PLANNING, ZONING, & BUILDING DEPARTMENT
PZ&B Staff Memorandum: Town Council Development Review

SUBJECT: ZON-23-034 (ARC-23-026) 171 EL PUEBLO WAY (COMBO)

The applicant has submitted plans, entitled "PRESSLY-RYAN RESIDENCE" as prepared by **SKA Architect + Planner (Jacqueline Albarran)** dated February 9, 2023.

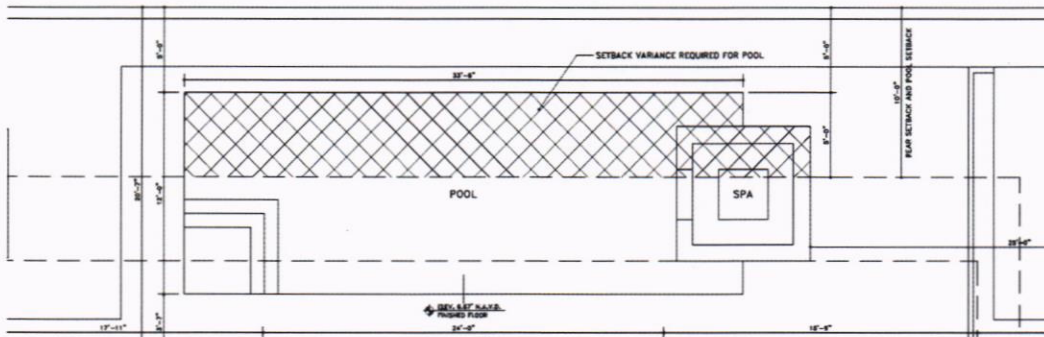
The zoning code for the R-B Zoning District permits for the reduction of a front yard setback up to five feet for the first and second story, provided that the rear yard setback increases by the same dimension. The applicant proposes a rear yard setback of 18' in lieu of 10' for the first story (+3') and 20' 7" in lieu of 15' for the second story (+5.58'). With the increase of the rear yard setbacks, the applicant proposes to reduce the front yard setback by proposing a first story front yard setback of 22' 6" in lieu of the 25' front yard setback required (-2.5') and a second story front yard setback of 25' in lieu of the 30' required (-5').

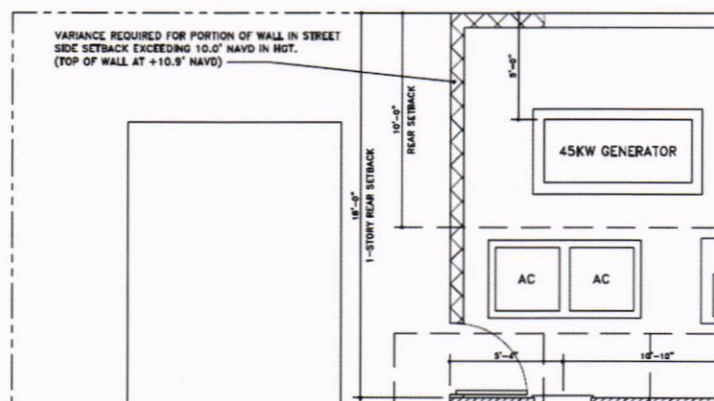
Code Section	Required	Proposed	Variance
Sec. 134-1667	A generator to be completely screened by a masonry wall not exceeding max wall height.	A generator screening wall which exceeds max wall height by 11" to completely screen the generator.	A wall height of 6' 11" in lieu of the 6' maximum permitted in a street side yard setback.

The existing site grade is lower than the required FEMA elevation, resulting in equipment required to be installed on stands or raised equipment pads. The zoning code requires that equipment be screened by a wall as high as the equipment, but not higher than allowed by code. In this instance, the applicant must install a screening wall which is less than 1' higher than allowed by code, so that the generator equipment will be completely screened from the street.

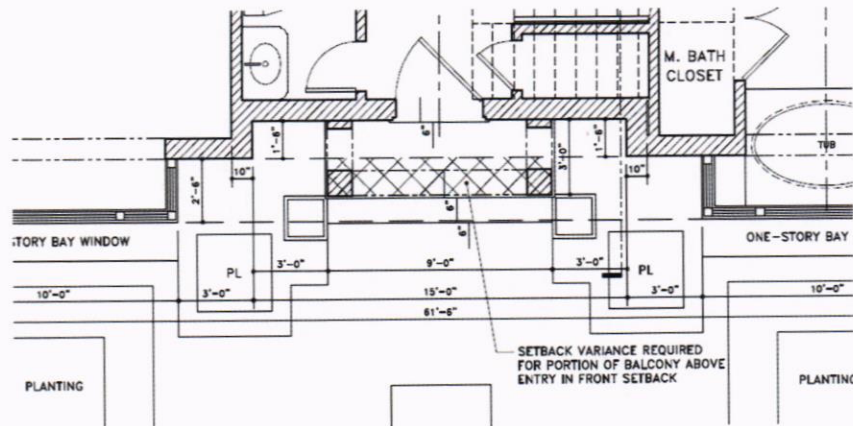
Code Section	Required	Proposed	Variance
Sec. 134-1093(b)(5)b	2 nd story balcony features must be located outside of the required 2 nd story setback.	A balcony feature which is located at a 23' setback in lieu of the 25' setback required.	2' second story front yard setback encroachment.

The applicant has reduced the front yard setback by increasing the rear yard setback, which is permitted by code. The applicant proposed an one story entry feature with a balcony. Because the balcony is considered a second story feature, it must meet the second story setback requirement. The applicant proposes for the entry to encroach 2' into the required 2nd story setback (but still outside of the one story setback).
